# GRSG-97-11e      Japan Proposal    Overview

(R125 Forward field of vision )

Japan's present proposal

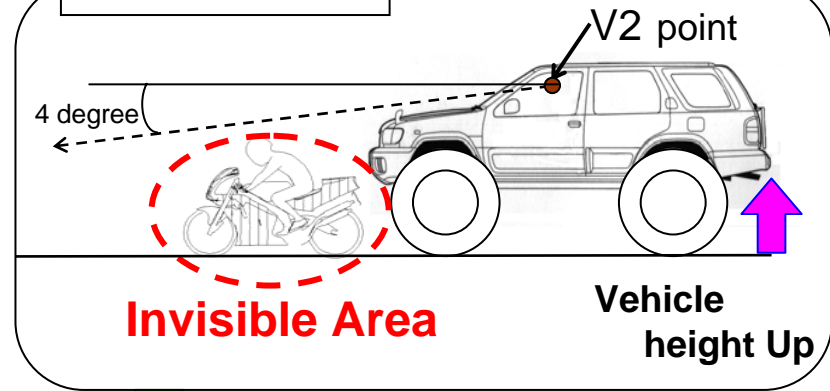
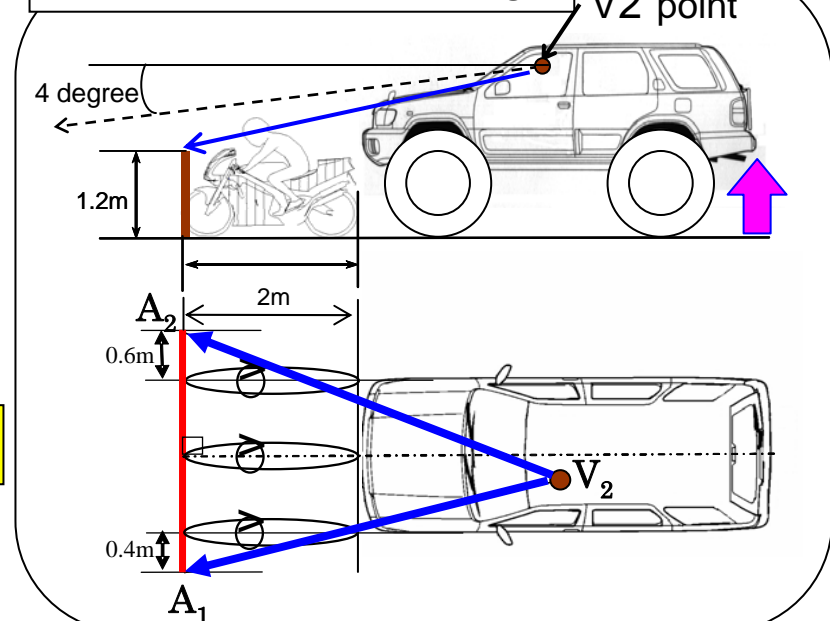
1. Need to ensure the field of vision in the lower area in front of the vehicle.
2. Under the current R125, an Invisible Area is generated when the vehicle height is increased.
3. Required Visible Range should be specified to enable the driver to see motorcycles in front.
4. Proposal:  
There should be no obstruction above the triangular plane (A1-A2-V2) (**GRSG-97-11e**).

# 3. Forward field of vision pattern

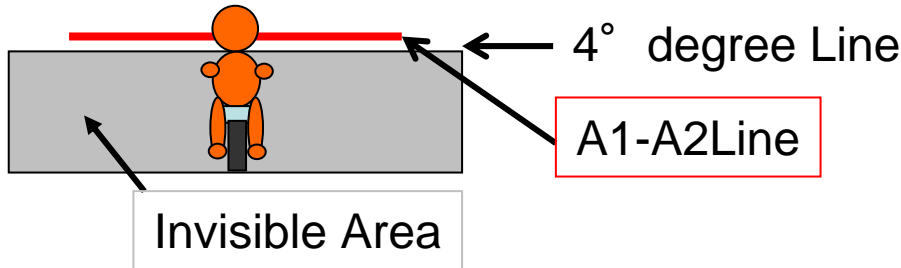
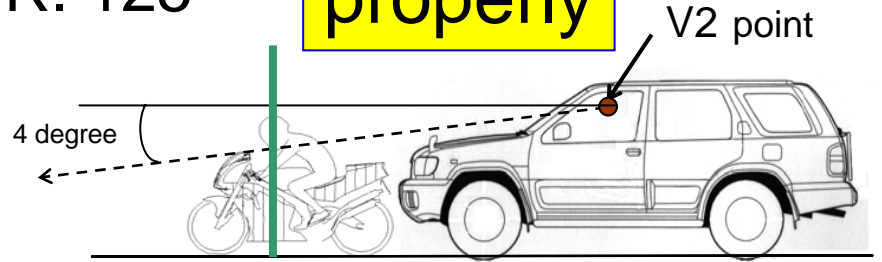
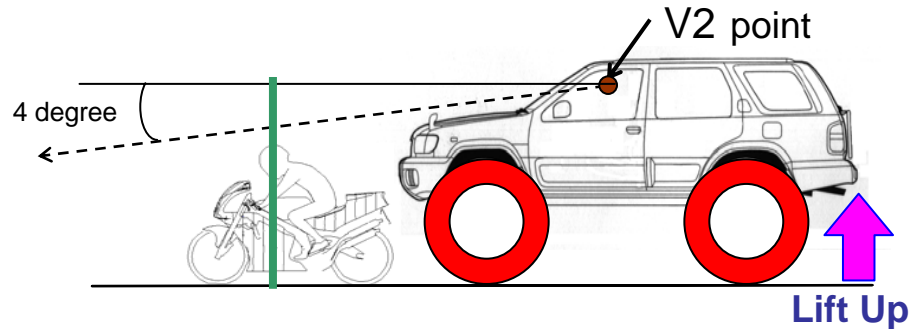
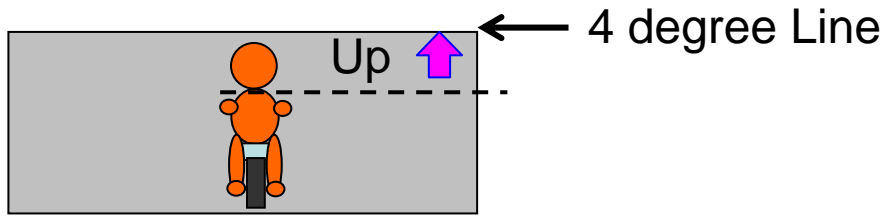
(A) Vision of a normal vehicle on R. 125

(B) Vision of a converted vehicle on R.125

(C) Vision of a converted vehicle on R.125 with Japan proposal
